MULLER ADDITION

RE: SUB2001-00125 MULLER ADDITION

At the regular meeting of the Subdivision Committee of the Metropolitan Area Planning Commission on Thursday, January 3, the above captioned plat was considered. The action of the Committee was to approve the final plat, subject to the following:

STAFF REPORT
(One-Step Final Plat)

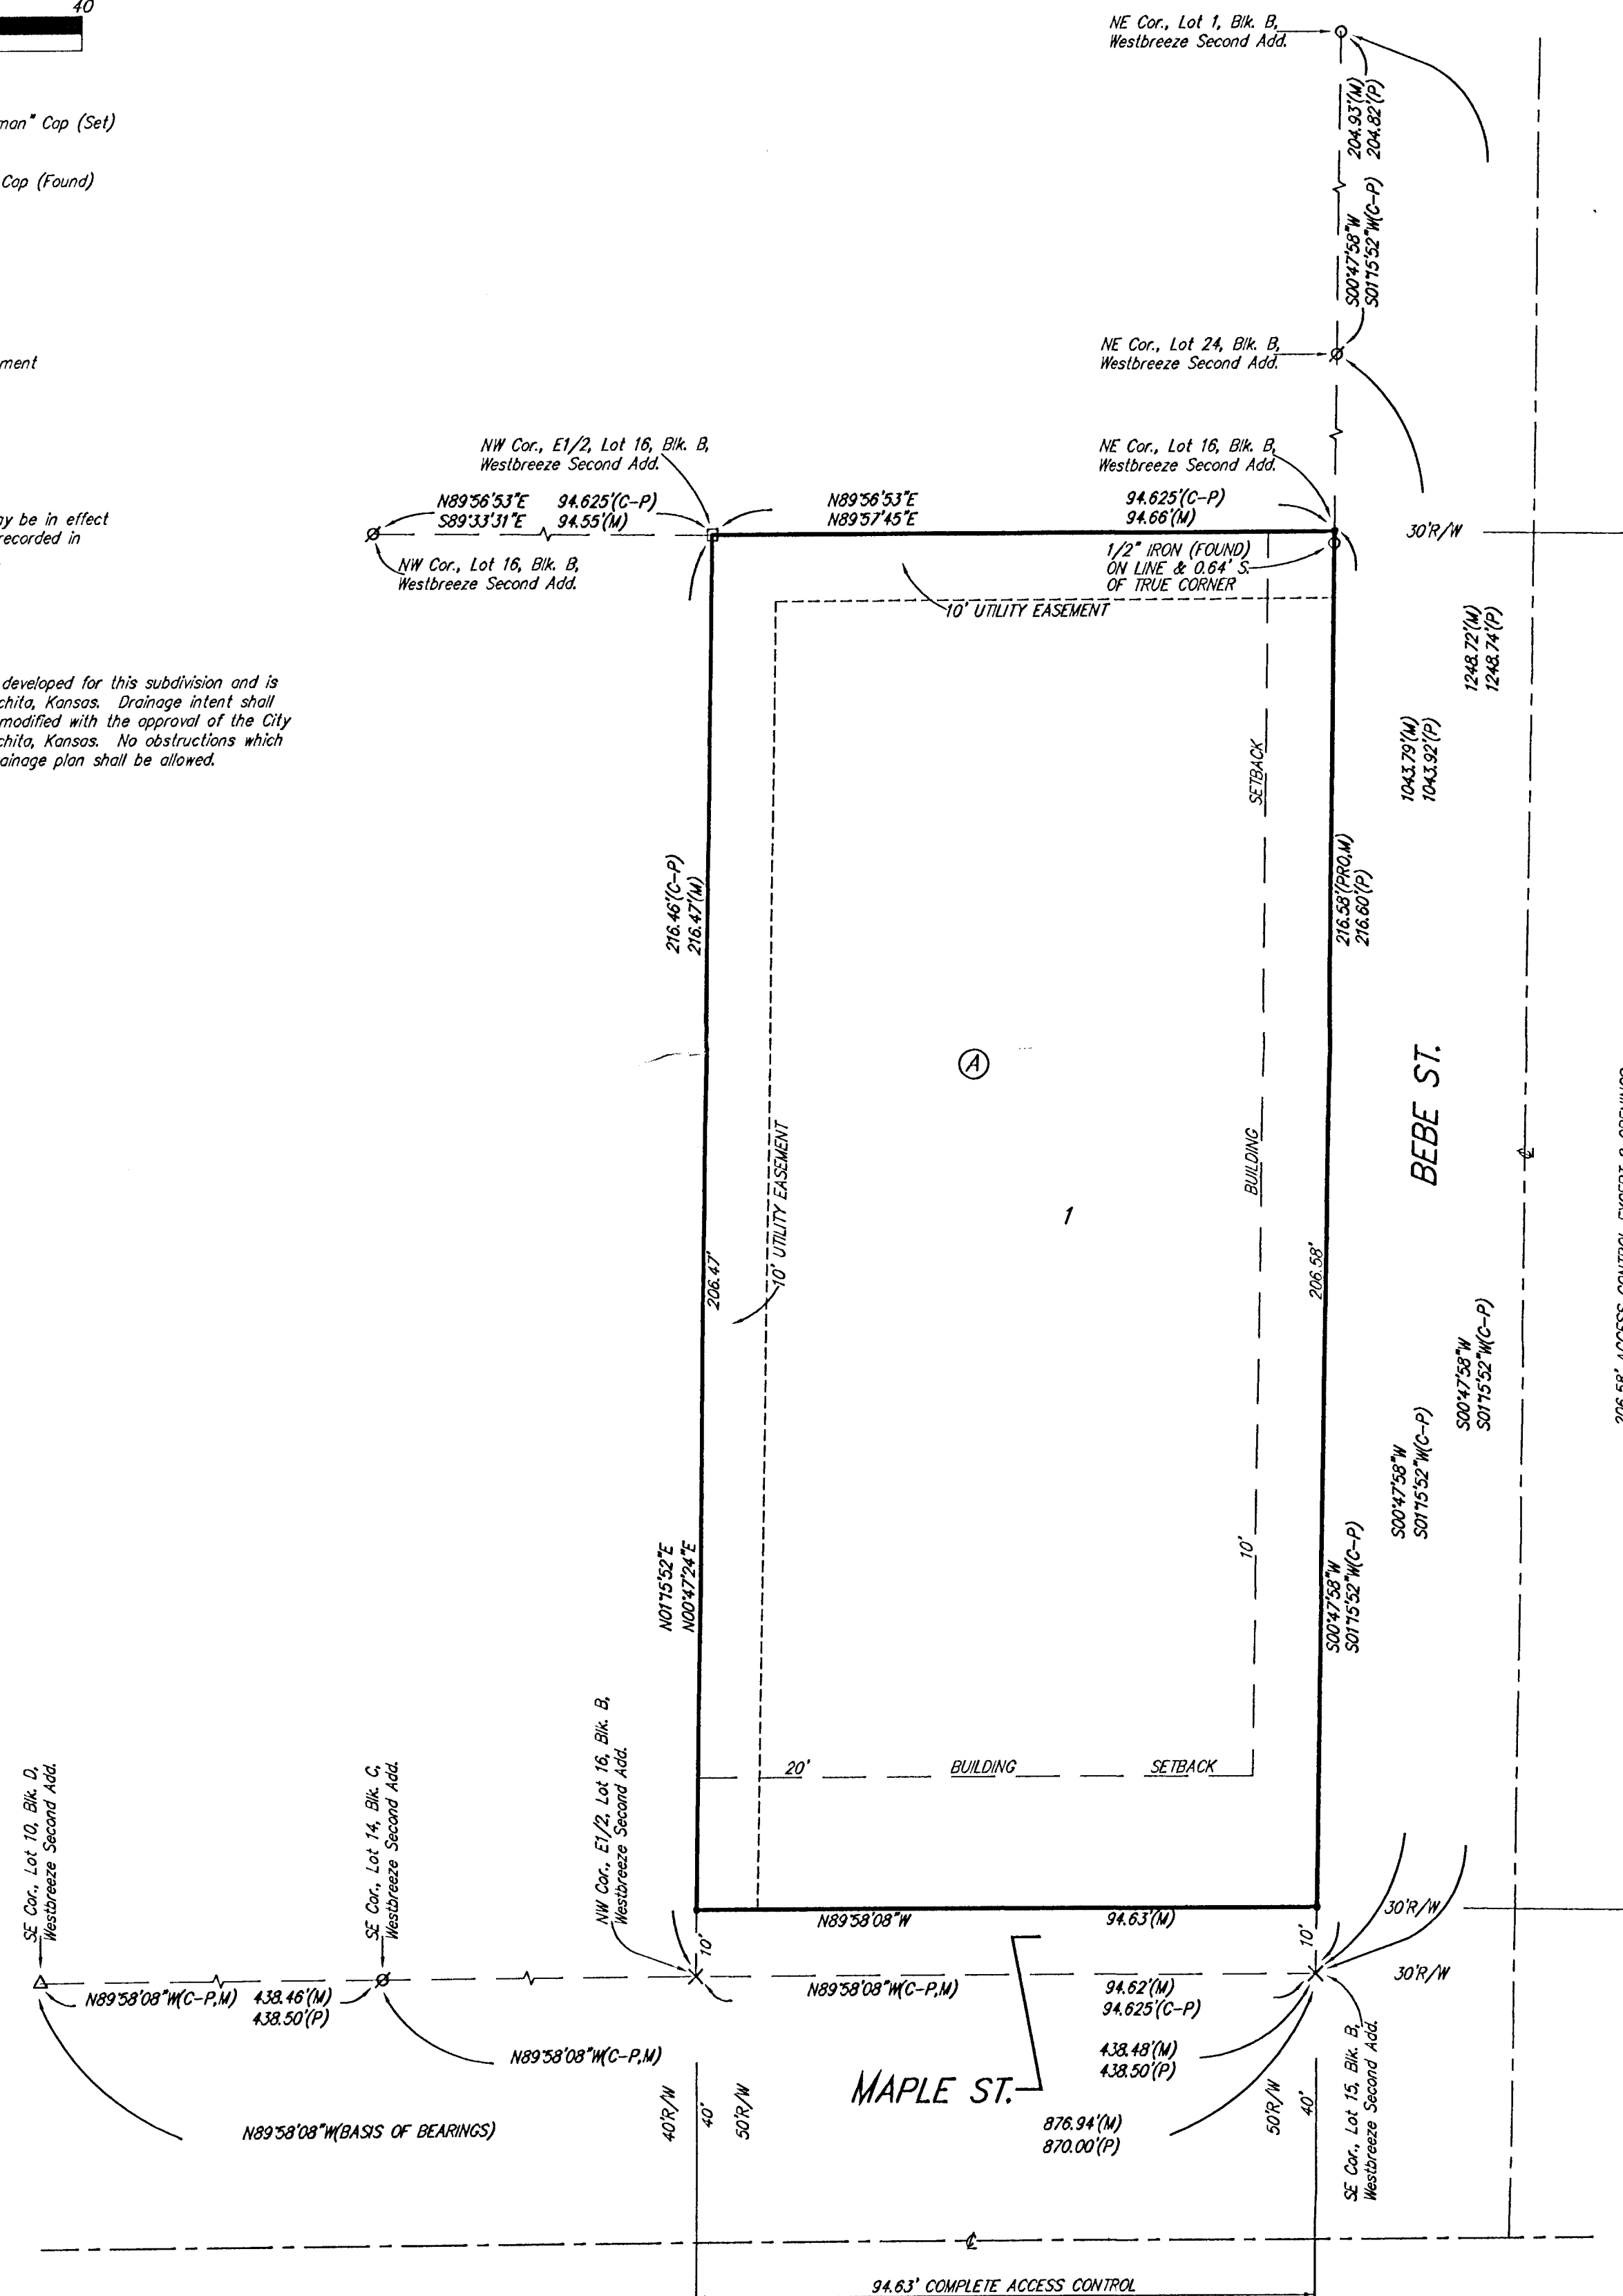
- C. City Engineering needs to comment on the status of the applicant's drainage plan. The drainage plan is approved.
- D. In accordance with the zone change approval, the plat proposes complete access control along Maple and two access openings along Bebe.

- F. As a commercial lot abutting a non-arterial street, the Subdivision regulations require a sidewalk along Bebe. A Sidewalk Certificate will be needed.

- G. Based upon the legal description shown on the plat, the site involves a 10-ft dedication of street right-of-way for Maple. The plat's text shall reference such dedication.

- J. The Applicant has platted a 10-ft building setback along Bebe which represents an adjustment of the Zoning Code standard of 20 feet for the NR District. (Bebe is classified as the Lot Frontage due to access from this street.) The Subdivision Regulations permit the setback provisions to be modified by the plat upon the approval of the Planning Commission.

- L. The platlor's text shall include language that a drainage plan has been developed for the plat and that all drainage easements, rights-of-way, or reserves shall remain at established grades or as modified with the approval of the applicable City or County Engineer, and unobstructed to allow for the conveyance of stormwater.

- N. The applicant's engineer is advised that the Register of Deeds is requiring the name(s) of the notary public, who acknowledges the signatures on this plat, to be printed beneath the notary's signature.
